Enhancements made compared to DC 295

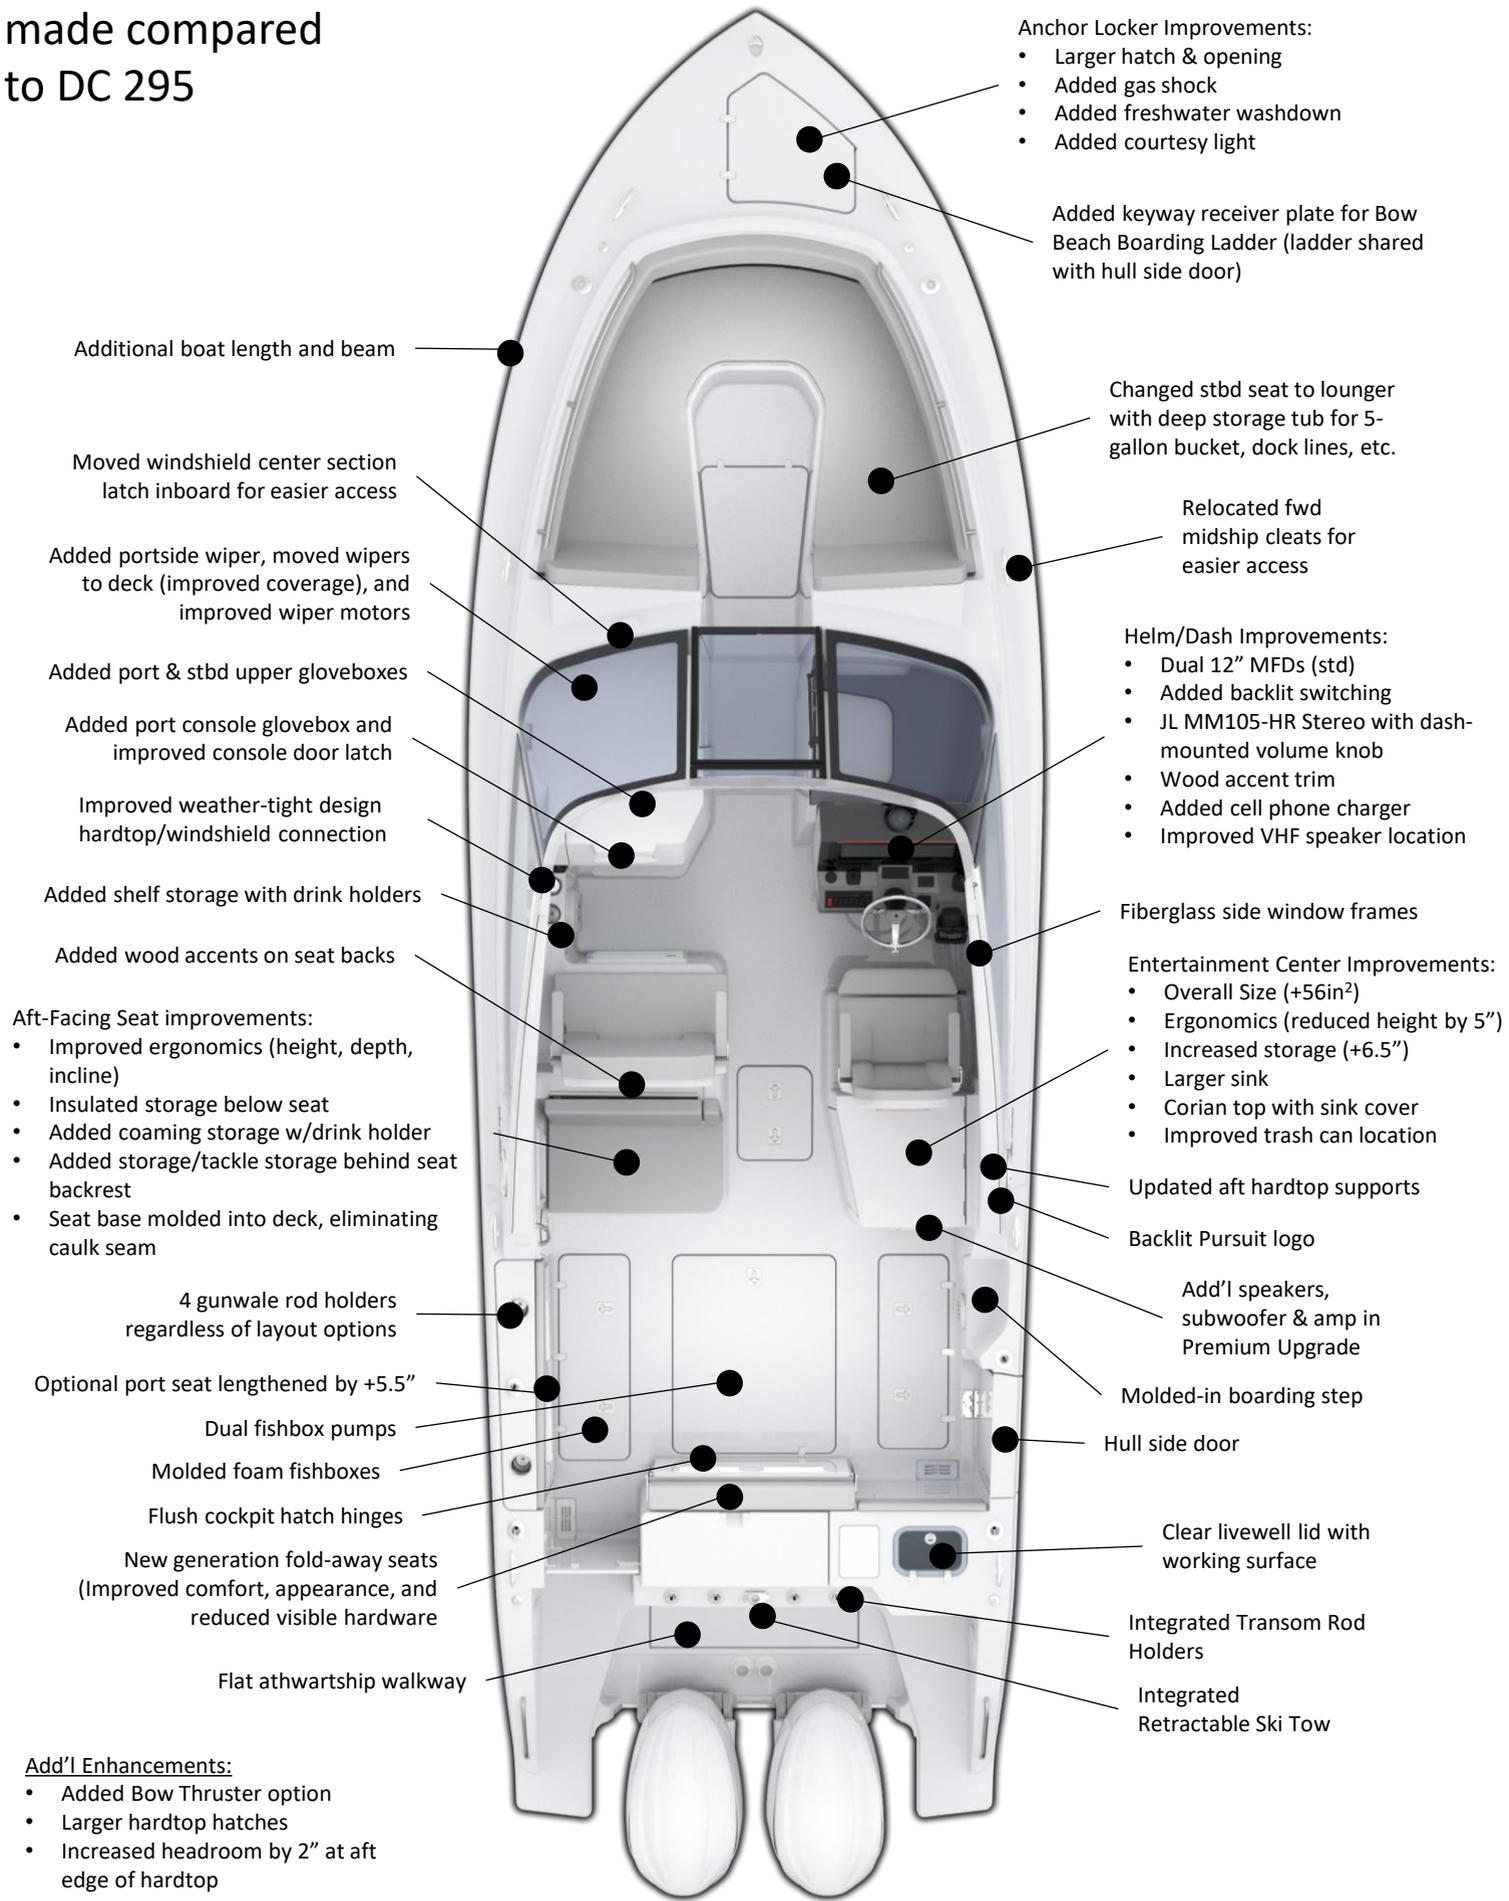
- Anchor Locker Improvements:**
- Larger hatch & opening
 - Added gas shock
 - Added freshwater washdown
 - Added courtesy light

Added keyway receiver plate for Bow Beach Boarding Ladder (ladder shared with hull side door)

Changed stbd seat to lounger with deep storage tub for 5-gallon bucket, dock lines, etc.

Relocated fwd midship cleats for easier access

- Helm/Dash Improvements:**
- Dual 12" MFDs (std)
 - Added backlit switching
 - JL MM105-HR Stereo with dash-mounted volume knob
 - Wood accent trim
 - Added cell phone charger
 - Improved VHF speaker location

Fiberglass side window frames

- Entertainment Center Improvements:**
- Overall Size (+56in²)
 - Ergonomics (reduced height by 5")
 - Increased storage (+6.5")
 - Larger sink
 - Corian top with sink cover
 - Improved trash can location

Updated aft hardtop supports

Backlit Pursuit logo

Add'l speakers, subwoofer & amp in Premium Upgrade

Molded-in boarding step

Hull side door

Clear livewell lid with working surface

Integrated Transom Rod Holders

Integrated Retractable Ski Tow

Additional boat length and beam

Moved windshield center section latch inboard for easier access

Added portside wiper, moved wipers to deck (improved coverage), and improved wiper motors

Added port & stbd upper gloveboxes

Added port console glovebox and improved console door latch

Improved weather-tight design hardtop/windshield connection

Added shelf storage with drink holders

Added wood accents on seat backs

Aft-Facing Seat improvements:

- Improved ergonomics (height, depth, incline)
- Insulated storage below seat
- Added coaming storage w/drink holder
- Added storage/tackle storage behind seat backrest
- Seat base molded into deck, eliminating caulk seam

4 gunwale rod holders regardless of layout options

Optional port seat lengthened by +5.5"

Dual fishbox pumps

Molded foam fishboxes

Flush cockpit hatch hinges

New generation fold-away seats (Improved comfort, appearance, and reduced visible hardware)

Flat athwartship walkway

Add'l Enhancements:

- Added Bow Thruster option
- Larger hardtop hatches
- Increased headroom by 2" at aft edge of hardtop
